CITY PLAN COMMISSION STAFF REPORT

CD-CPC-2025-00133

Executive Park Lot 6 Major Amendment

Rezoning to UR - Major Amendment

REVISION

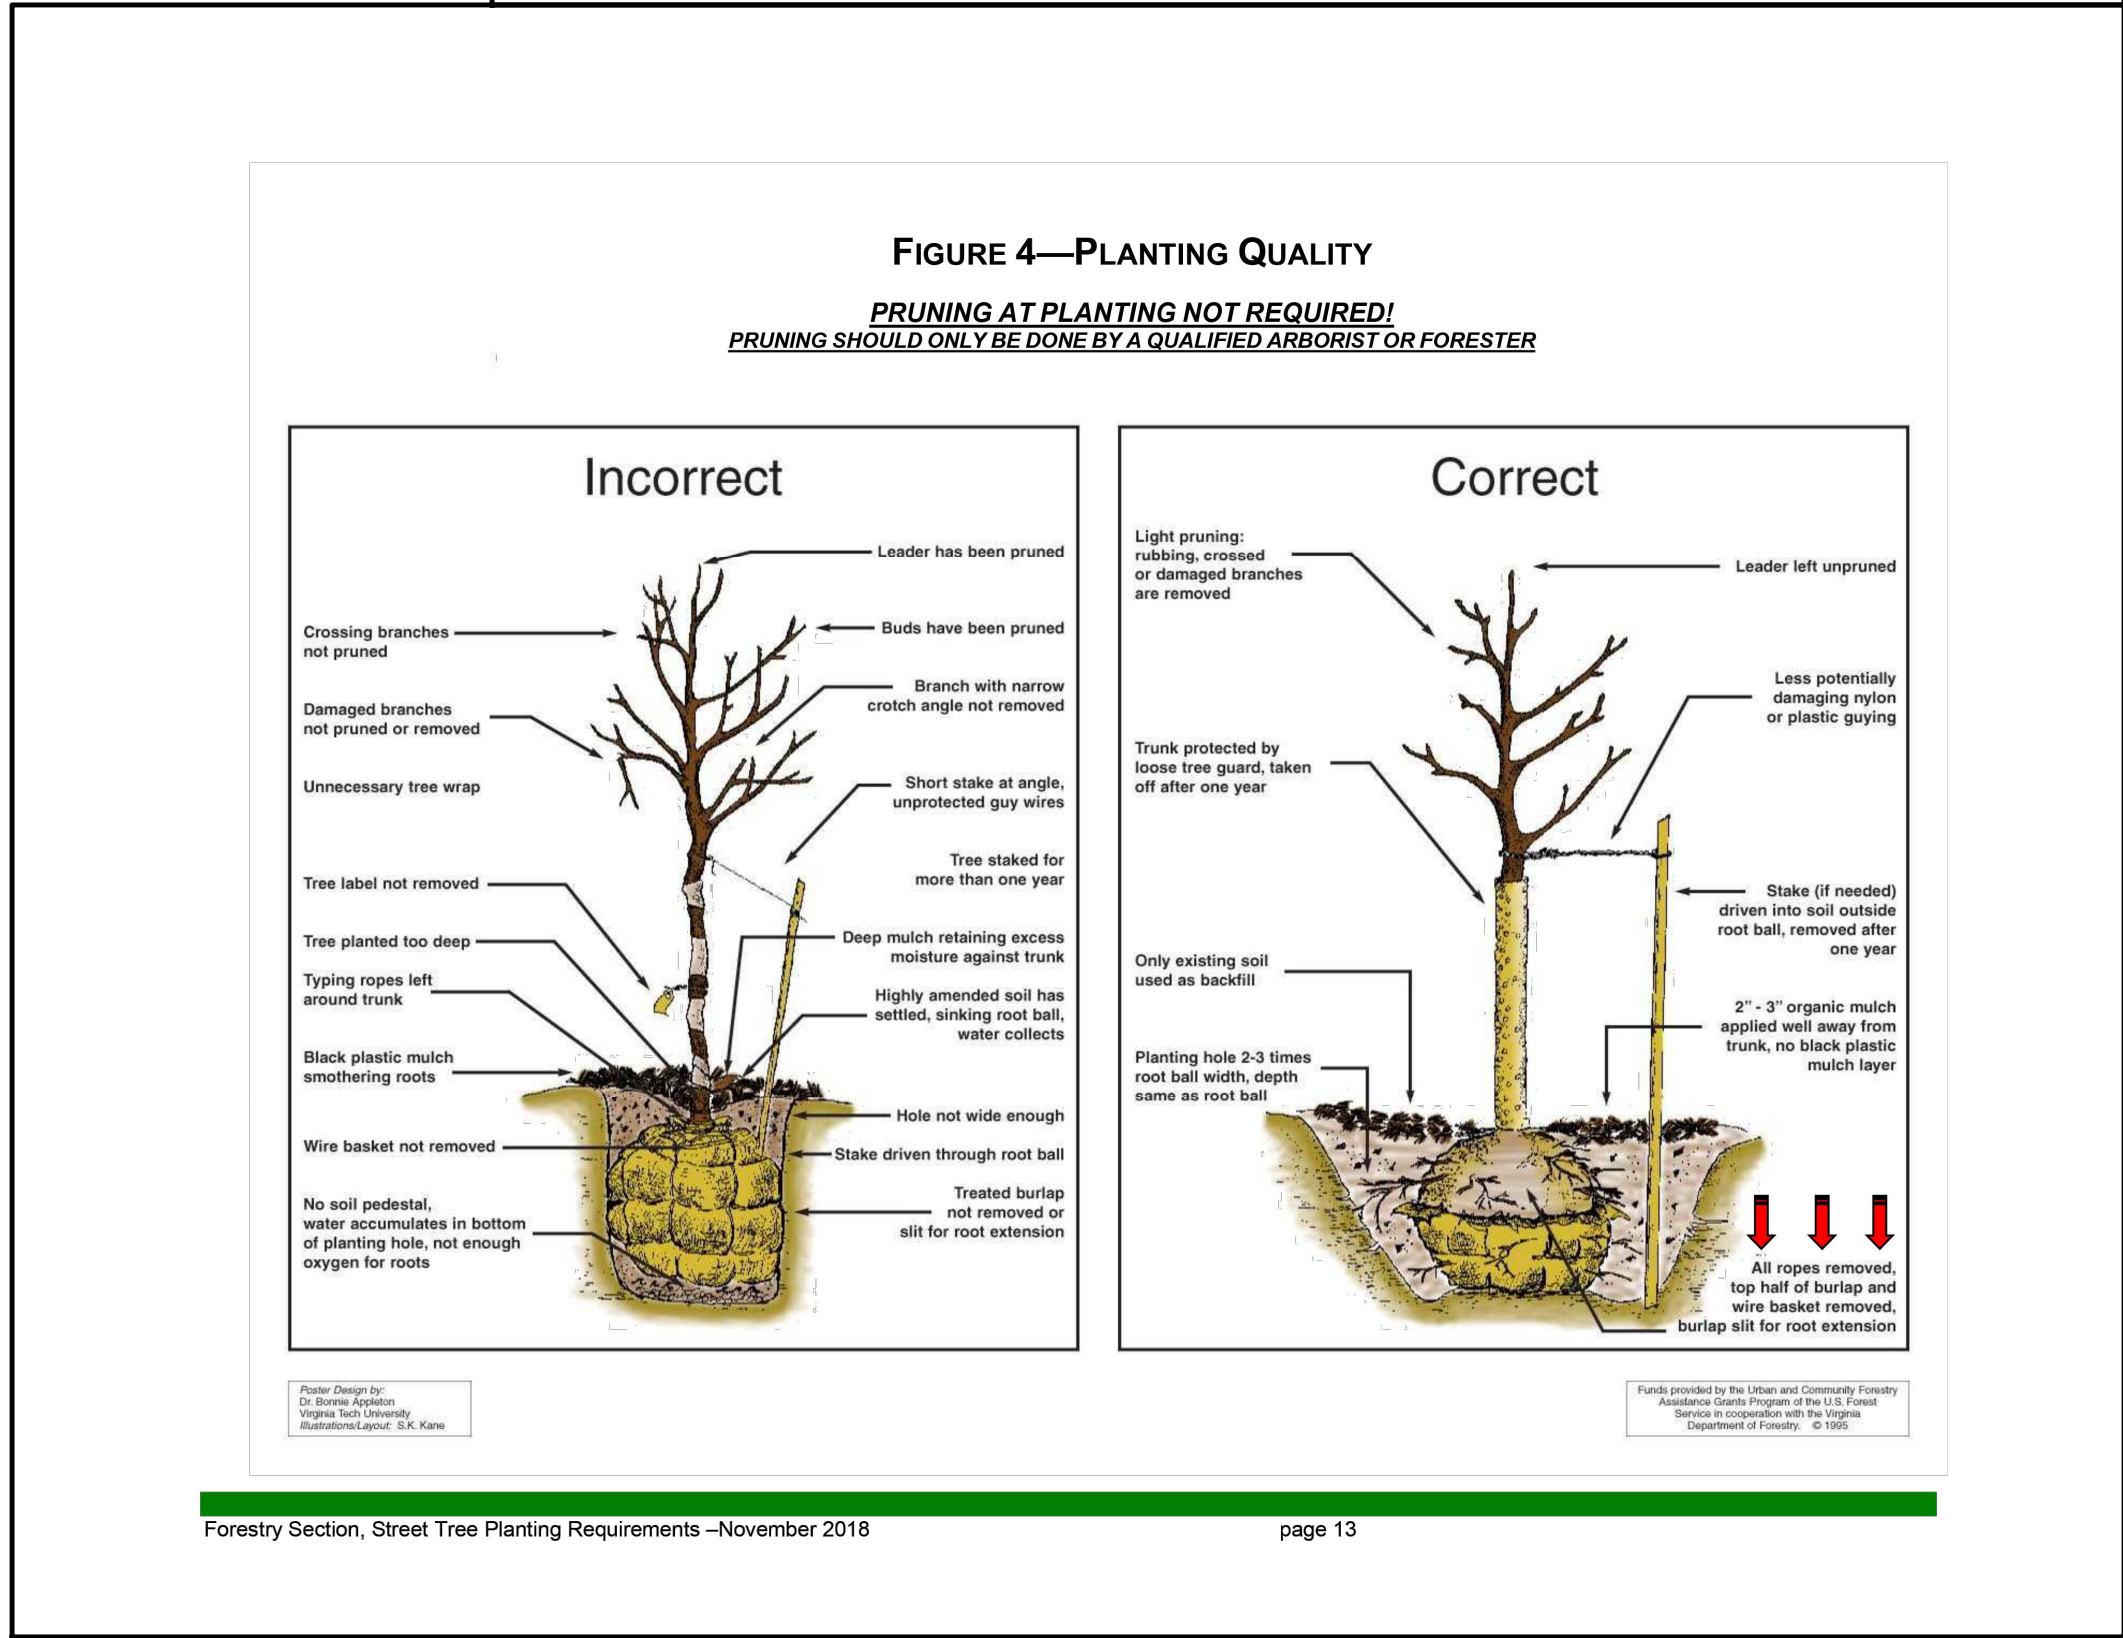
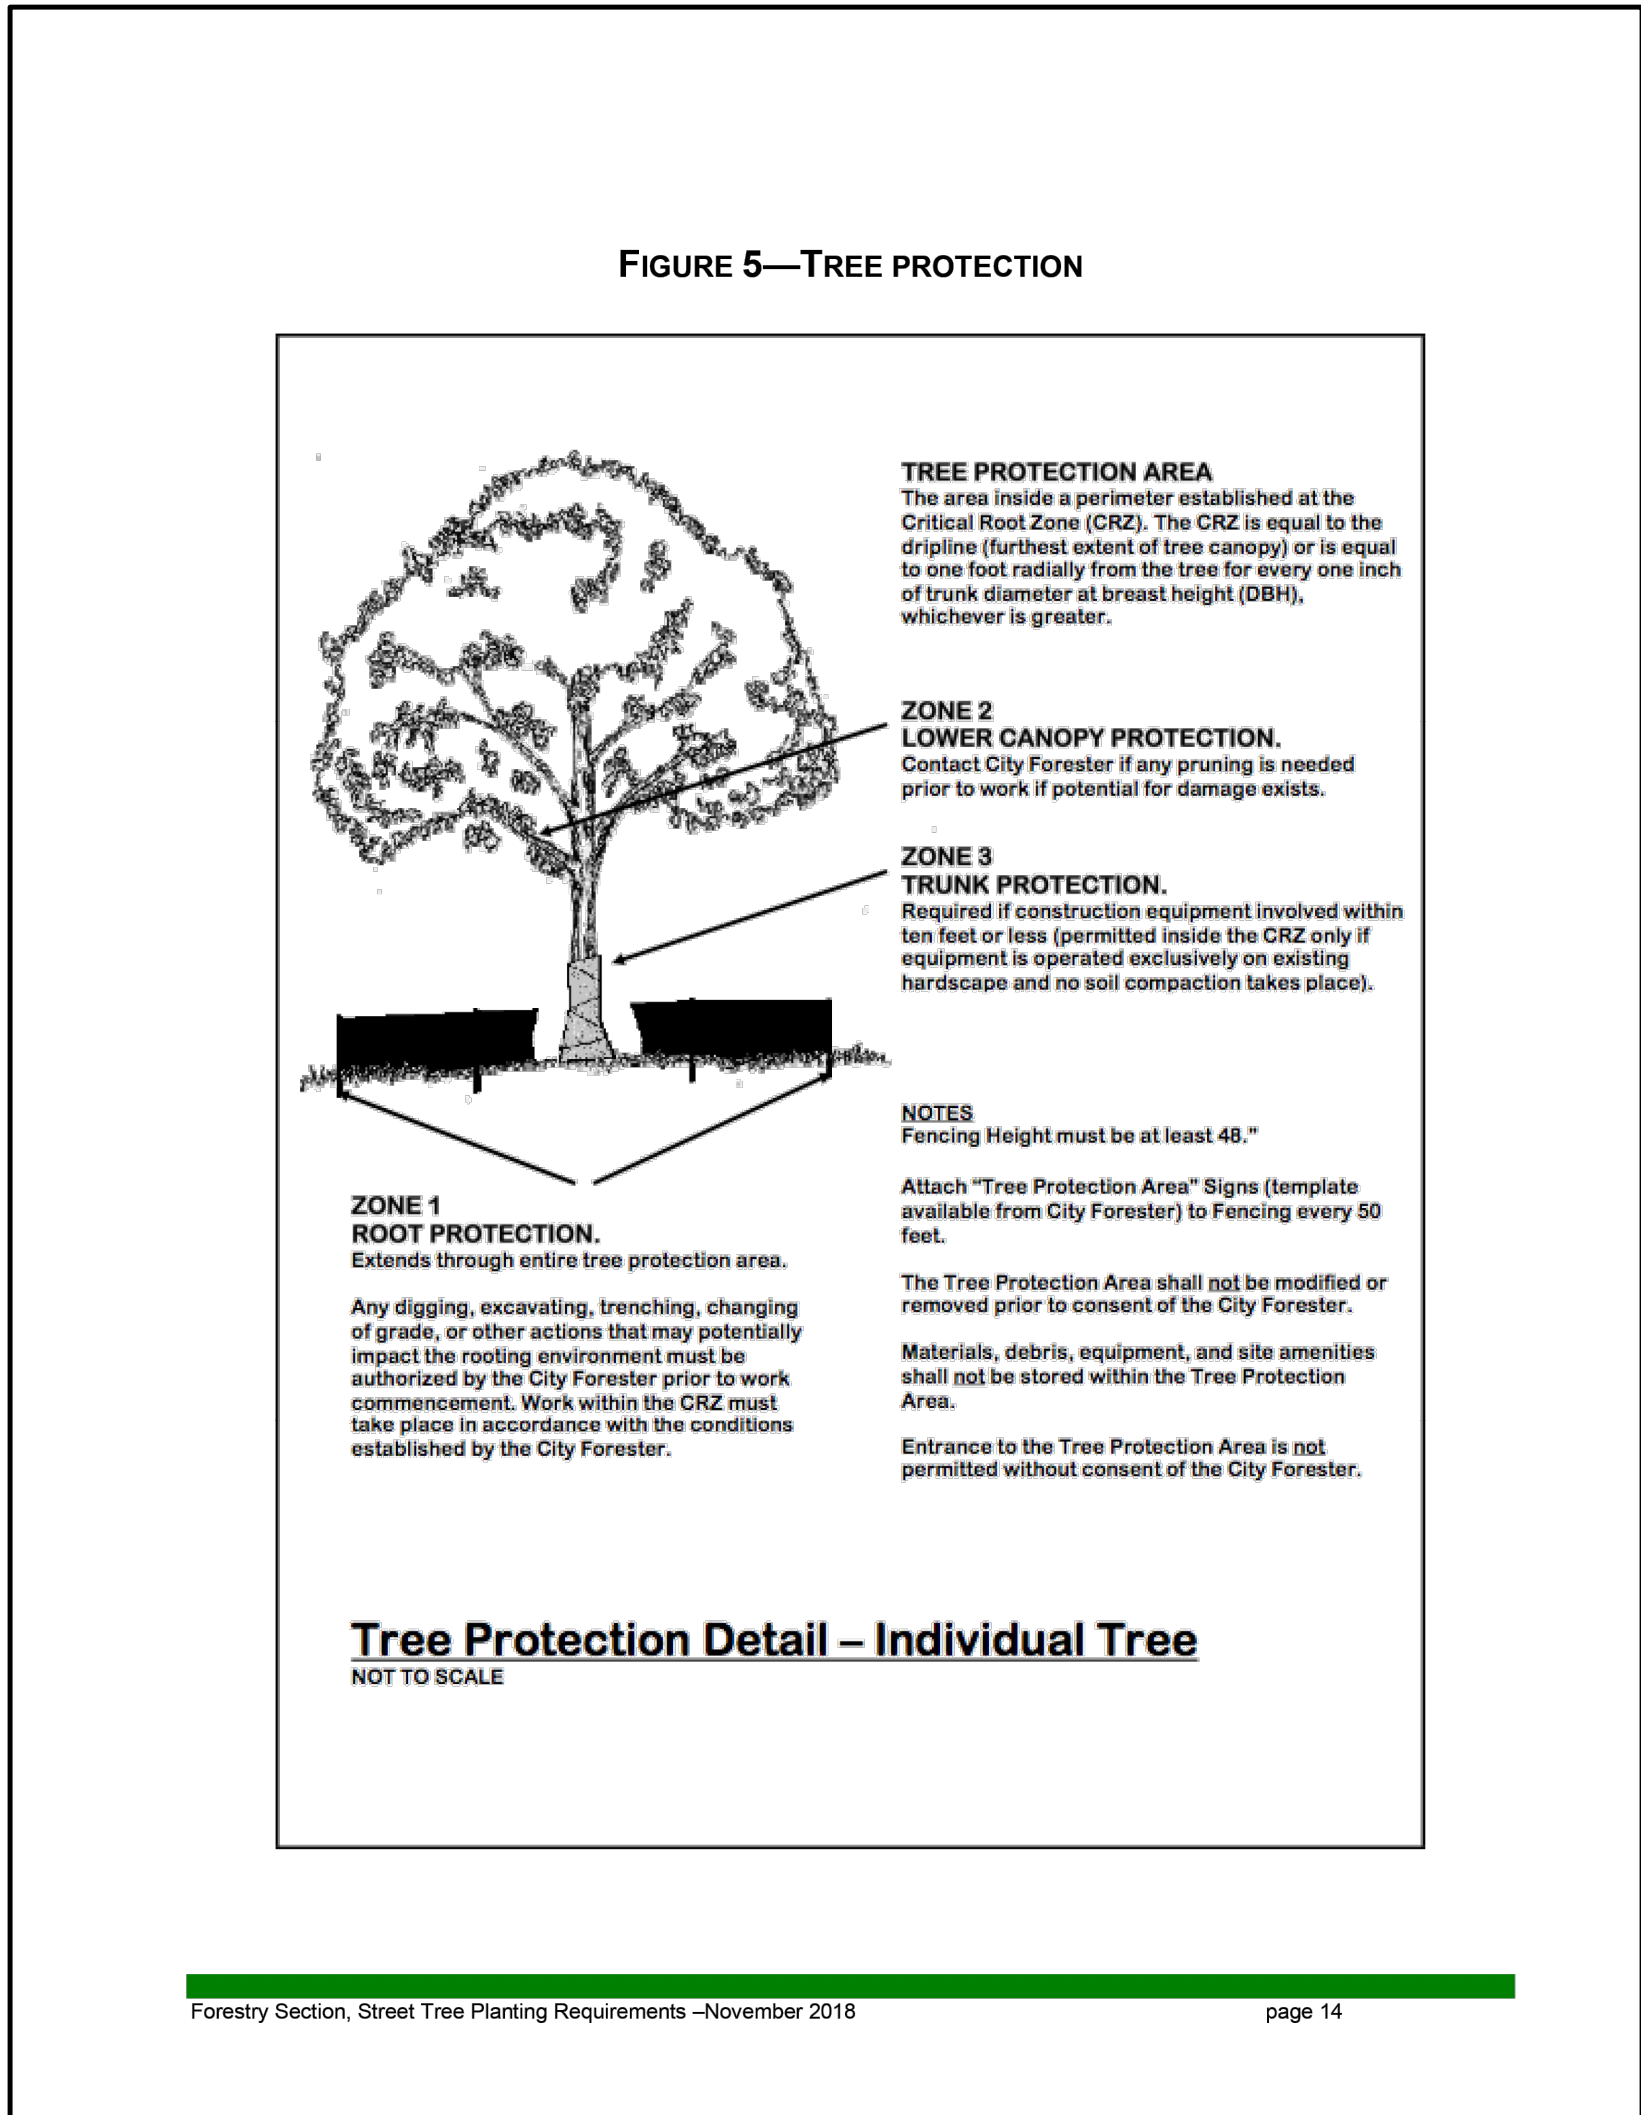
The applicant worked with staff to provide appropriate landscaping throughout the site. The applicant will be required to work with the Police Department prior to ordinance request regarding a remaining correction on the submitted photometric plan.

2. Identify the maximum height of plantings in close proximity to lighting elements. The mature height of these planting shall not impact or lessen the foot-candles shown on the approved photometric plan.
